# **CITY OF CONWAY, ARKANSAS HISTORIC DISTRICT COMMISSION**

January 25, 2021 · 5:30pm

# Exterior Modifications

# New Detached Garage and Exterior Modifications

REAR ELEVATION

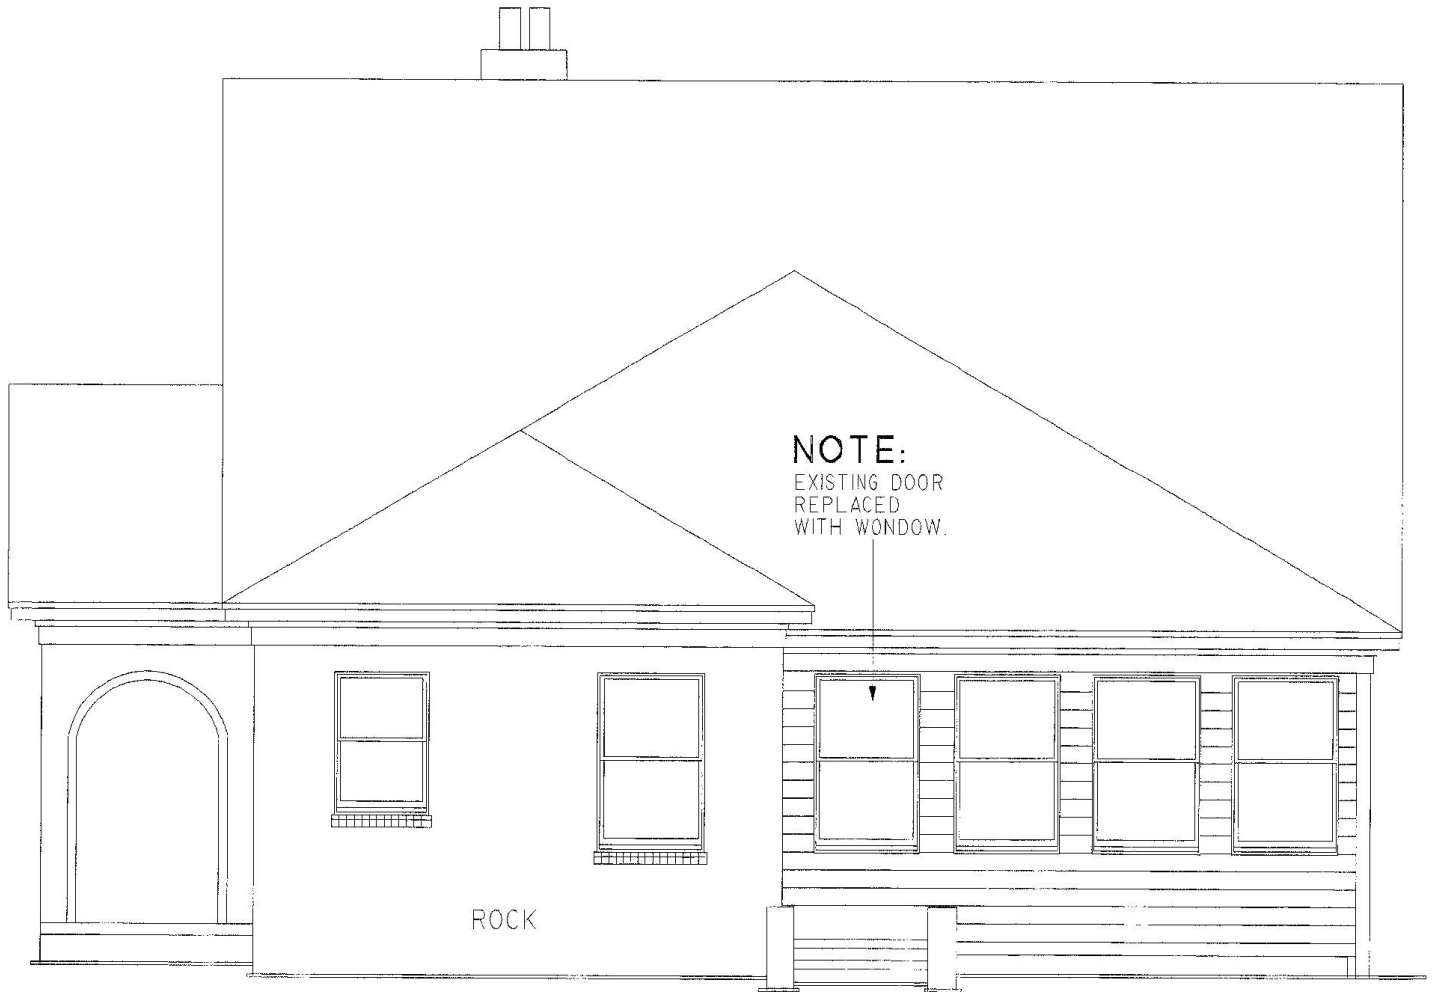
*The applicant is proposing to replace all windows and add a window where the rear sunroom door is located. All new and replaced windows must feature true divided lights windows. Vinyl windows must be 1 over 1 windows. The proposed replacement door design is appropriate.*

**Architectural Details, Siding, and Bricks.** The existing sunroom addition is clad in vinyl siding. The applicant is proposing to replace the existing sunroom door with a window and backfill the portion below the window with matching siding. Although vinyl siding is not considered an appropriate material in Old Conway, the minimal use to match an existing façade is appropriate in this instance.

**PLOT PLAN**  
SCALE: 1" = 20'-0"

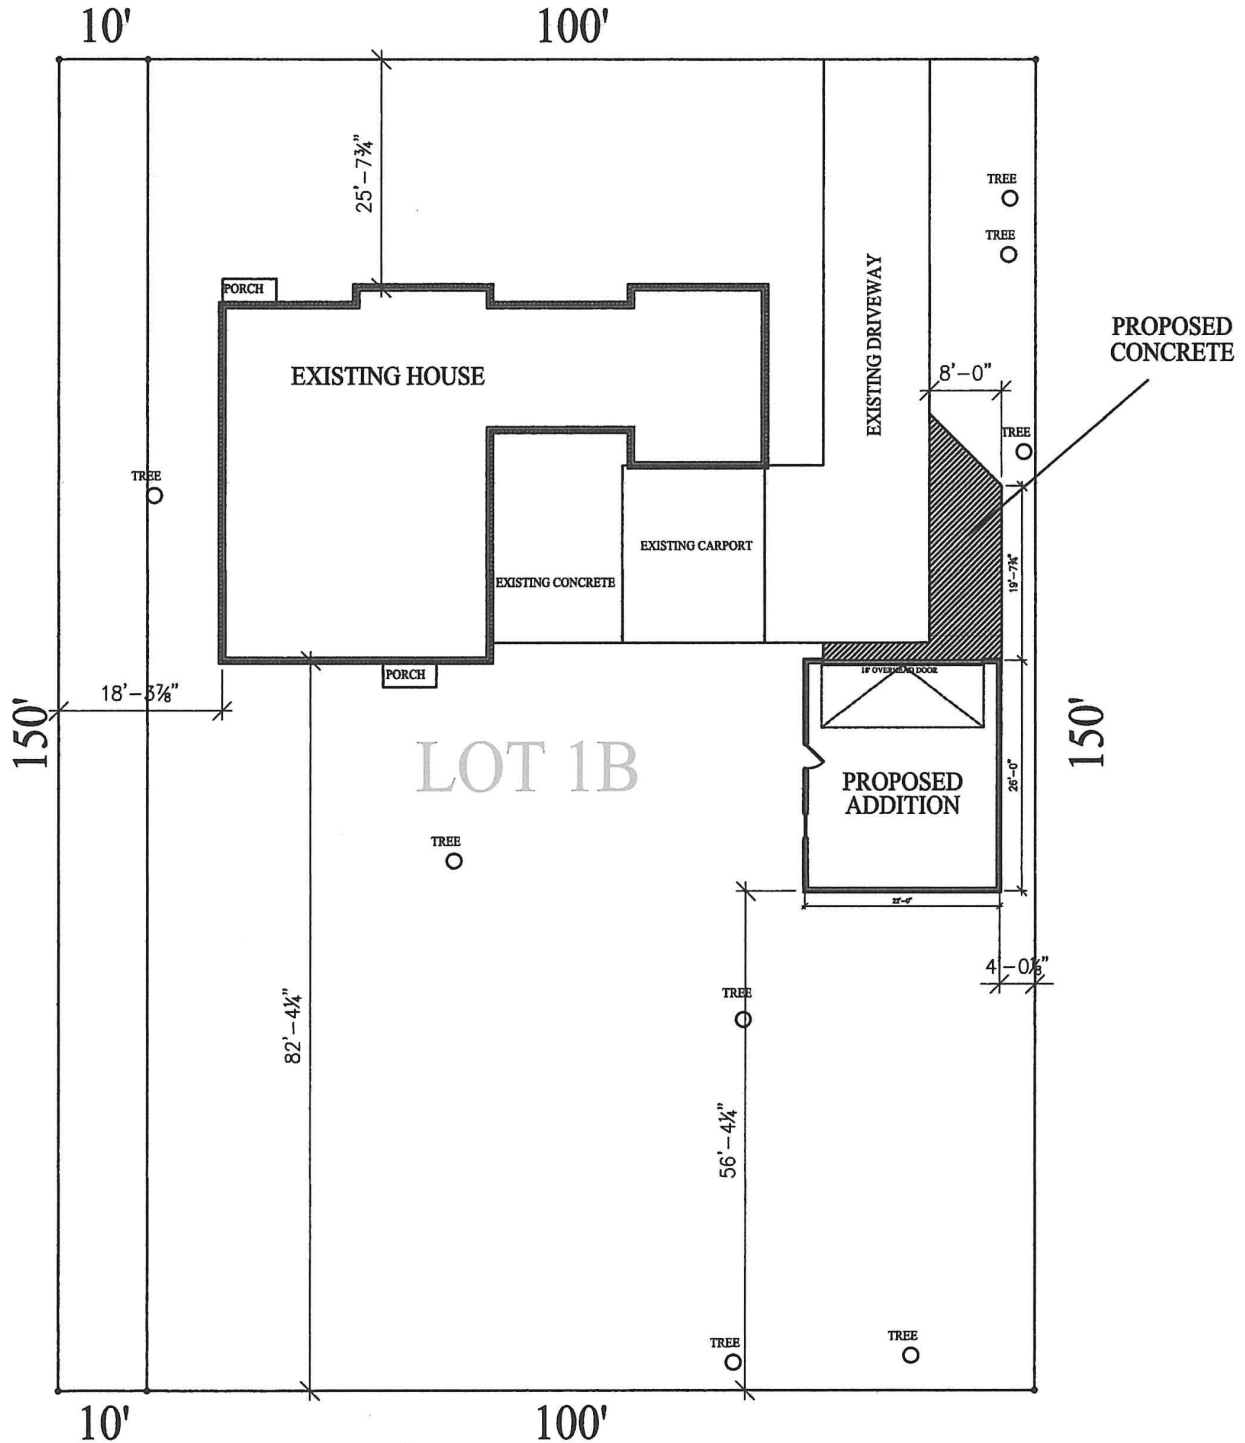
*The proposed setbacks for the garage are 4'. The structure's location will need to be moved to accommodate fire code requirements. The proposed location of the garage places it within 10' of the primary structure. This would violate the fire code. To comply the carport would need to be removed, the structures tied together under roof, or the garage location moved.*

*A previous owner made parking improvements without authorization related to the unpermitted replacement of a carport. The existing parking and driveway are appropriate to the location. The proposed addition of concrete will likely need to change based on necessary changes to the application.*

1. Remove the existing carport or move the proposed garage to an appropriate location that meets the requirements of the fire code.
2. Require a solid roof deck and traditional roofing materials be used to replace the existing metal roofing on the carport.
3. Wood siding or a wood equivalent such as Hardieboard be used for cladding on the garage.
4. Require true 1 over 1 windows for all windows on the garage.
5. Require fascia and soffits to be finished with wood or wood equivalent construction such as Hardieboard.
6. Any trees removed over 8" in diameter shall be replaced.
7. Plans shall be resubmitted to the Planning Director for approval prior to issuance of the COA.
